Flood Damage Reduction Segment / System Inspection Report

Name of Segment / System: Ardsley Flood Control Project

**Flood Damage Reduction Segment / System
Inspection Report
Ardsley Flood Control Project (NAR1)**

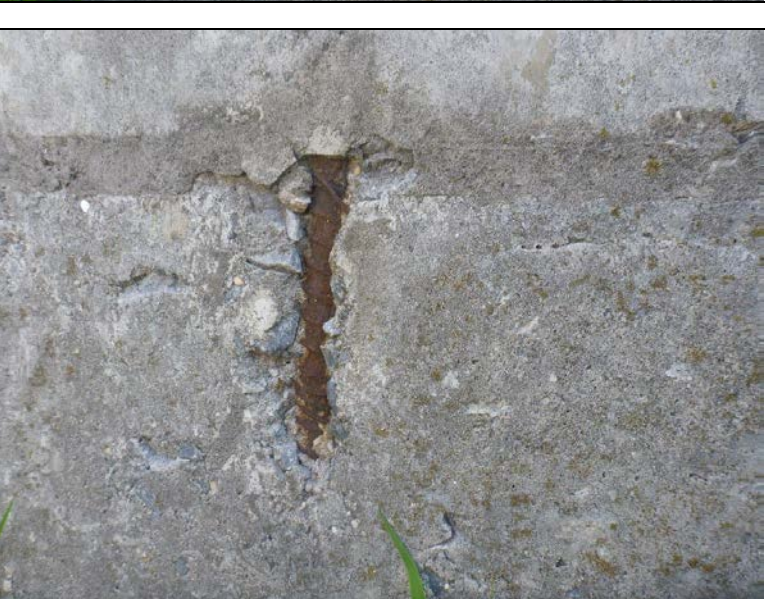
<p>Inspect ID: NAR1_2019_a_0023 Title: USACE_CENAN_NAR1_2019_a_0023_1.jpg Rated Item: 4. Concrete Surfaces Caption: Rating: Minimally Acceptable; Remarks: Spall with efflorescence at top of monolith 51 on the unprotected side. Could not access in 2019.; Action: Repair concrete surface in accordance with USACE Guidelines.; Station_1: 2+80B; Photo taken prior to the 2019 inspection.</p>
	<p>Inspect ID: NAR1_2019_a_0026 Title: USACE_CENAN_NAR1_2019_a_0026_1.jpg Rated Item: 4. Concrete Surfaces Caption: Rating: Minimally Acceptable; Remarks: Minor spalling on the protected side of monolith 47 near joint.; Action: Repair concrete surface in accordance with USACE Guidelines.; Station_1: 2+20B</p>

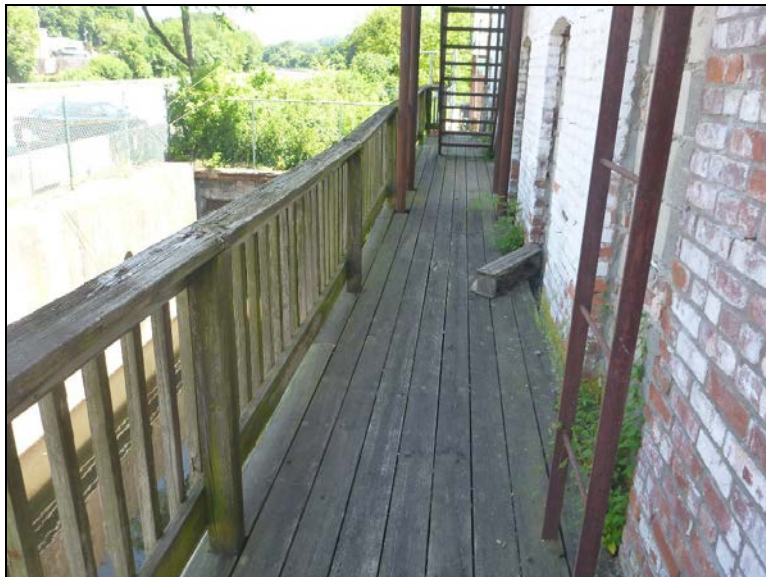
<p>Inspect ID: NAR1_2019_a_0046 Title: USACE_CENAN_NAR1_2019_a_0046_1.jpg Rated Item: 2. Encroachments Caption: Rating: Minimally Acceptable; Remarks: Two 8" PVC pipes that discharge in ponding area #2 are not shown on the project plans. Some erosion has occurred below the southernmost pipe; Action: Local sponsor should investigate and document the encroachments. ; Station_1: 5+15U; ;</p>
	<p>Inspect ID: NAR1_2019_a_0046 Title: USACE_CENAN_NAR1_2019_a_0046_2.jpg Rated Item: 2. Encroachments Caption: Rating: Minimally Acceptable; Remarks: Two 8" PVC pipes that discharge in ponding area #2 are not shown on the project plans. Some erosion has occurred below the southernmost pipe; Action: Local sponsor should investigate and document the encroachments. ; Station_1: 5+15U; ;</p>

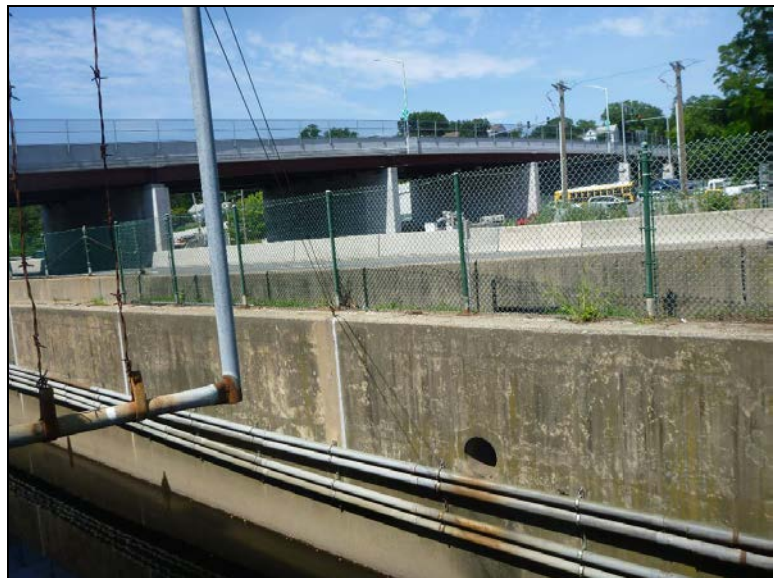
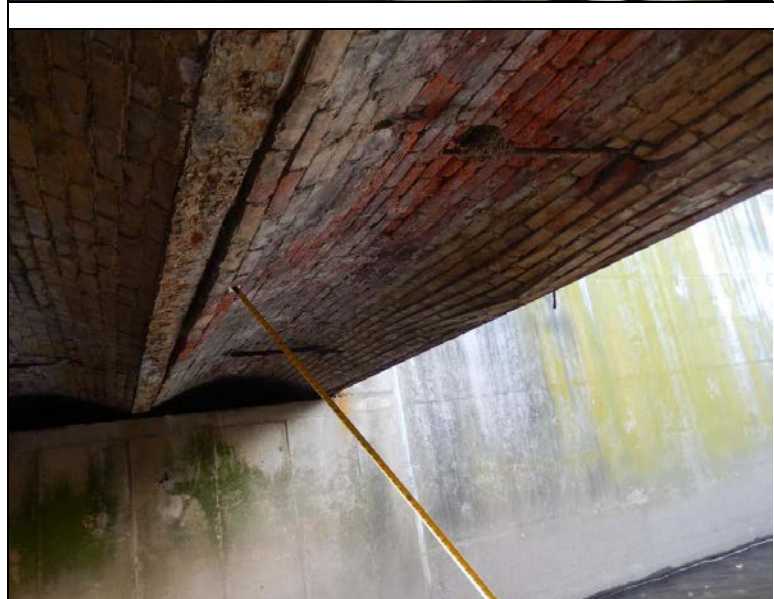
<p>Inspect ID: NAR1_2019_a_0076 Title: USACE_CENAN_NAR1_2019_a_0076_1.jpg Rated Item: 2. Shoaling (sediment deposition) Caption: Rating: Minimally Acceptable; Remarks: Shoaling in channel between monoliths 13 and 14. Could not access in 2019.; Action: Remove sediment in accordance with USACE guidelines.; Station_1: 3+15U; Photo taken prior to the 2019 inspection.</p>
	<p>Inspect ID: NAR1_2019_a_0058 Title: USACE_CENAN_NAR1_2019_a_0058_1.jpg Rated Item: 3. Encroachments Caption: Rating: Minimally Acceptable; Remarks: Old drainage inlets at Ardsley Square may not have been properly abandoned. 20" pipe from channel wall remains open. Could not access in 2019.; Action: Confirm that pre-project catch basins were abandoned according to the approved plan.; Station_1: 1+80U; Photo taken prior to the 2019 inspection.</p>

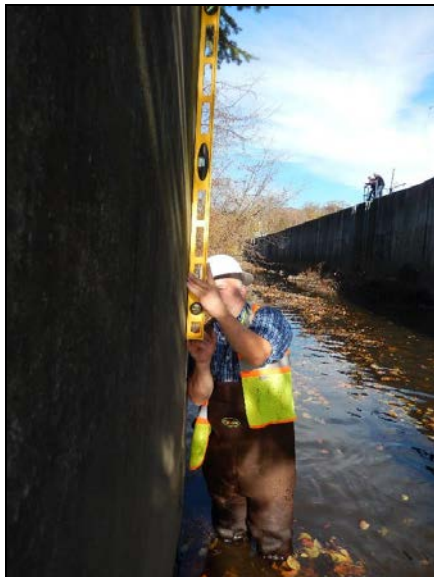
<p>Inspect ID: NAR1_2019_a_0070 Title: USACE_CENAN_NAR1_2019_a_0070_1.jpg Rated Item: 5. Concrete Surfaces Caption: Rating: Minimally Acceptable; Remarks: Concrete of Ashford Avenue bridge on left side is severely deteriorated and its failure could compromise integrity of concrete channel. Could not access in 2019 due to overgrown vegetation.; Action: Request NYSDOT to repair bridge abutment in order to protect the concrete channel.; Station_1: 0+00U; Photo taken prior to the 2019 inspection.</p>
	<p>Inspect ID: NAR1_2019_a_0077 Title: USACE_CENAN_NAR1_2019_a_0077_1.jpg Rated Item: 6. Tilting, Sliding or Settlement of Concrete Structures Caption: Rating: Minimally Acceptable; Remarks: Right channel wall tilting toward channel 1/4" over 4', between monolith 21 and 22. Could not access in 2019.; Action: Monitor displacement of the concrete monoliths to determine if movement is active.; Station_1: 4+35U; Photo taken prior to the 2019 inspection.</p>
